**FILE** P. I. No. M002966 Haralson-Carroll Counties **OFFICE** Preconstruction  
CSNHS-M002-00(966)  
I-20 Pavement Reconstruction **DATE** May 24, 2005

**SUBJECT: CONCEPT REPORT**

PROJECT CONCEPT REPORT

Project Number: CSNHS-M002-00(966)

DRAWING No.  
5-02

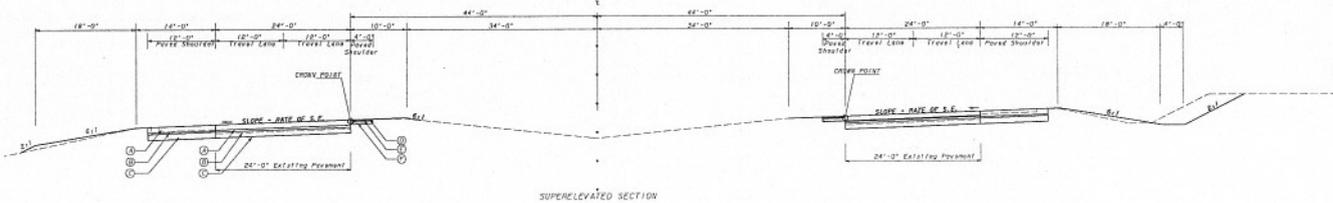
6. The question was raised as to what the actual shoulder widths would be. The report says one thing and the typicals say another. Andy Casey clarified that the shoulders would be 10' graded with 4' being paved.

7. James Magnus questioned what the pavement on the shoulders would be and the best choice was discussed. Buddy Gratton asked if the 4' of paving on the shoulder was needed for staging and it was said that it was so therefore the 4' on the shoulder would need to be full depth.
